WETLANDS REVIEW BOARD REGULAR MEETING

April 19, 2018

MEMORANDUM

SUBJECT: Minor subdivision of one lot into nine lots

UTILITY & DRAINAGE PLAN

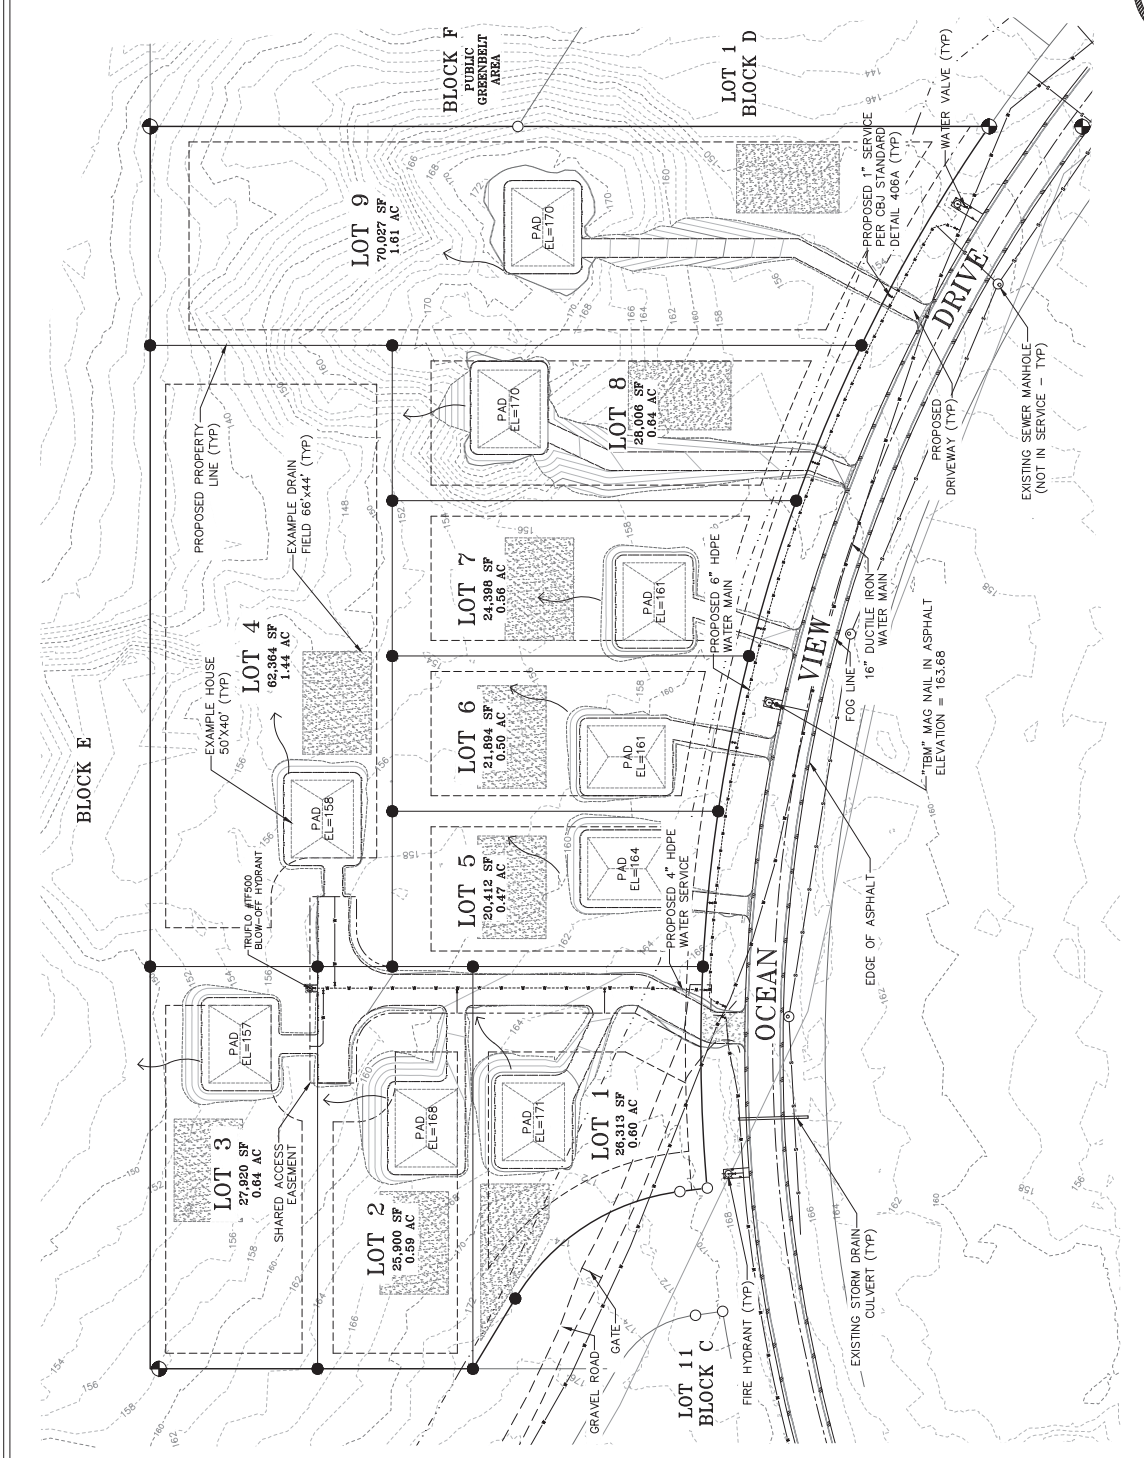
A number of drainage plans have been suggested to date, and these will have implications for wetlands on CBJ lots. The applicants have proposed sheet flow drainage across the subdivision toward the neighboring CBJ lot. However, CBJ Lands Division has concerns that should they develop their adjacent parcel, the additional surface runoff from the subject subdivision would add additional cost to the CBJ drainage plan.

CBJ Lands Division would prefer that surface water drainage be diverted away from its current natural drainage path either toward the CBJ greenbelt or to Ocean View Drive using a series of ditches and culverts. The latter suggestion would require a new culvert to be added under Ocean View Drive.
